## KAMBALA SPORTS PRECINCT DEVELOPMENT

## Response to Department of Planning Comments on Flood Risk

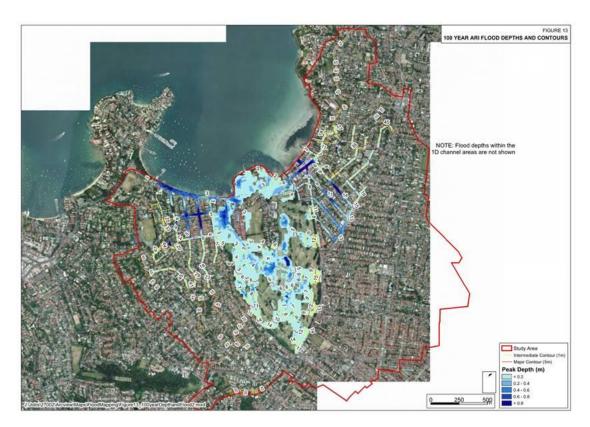
The following council flood map shows no significant flood path through the Kambala Sports precinct development area
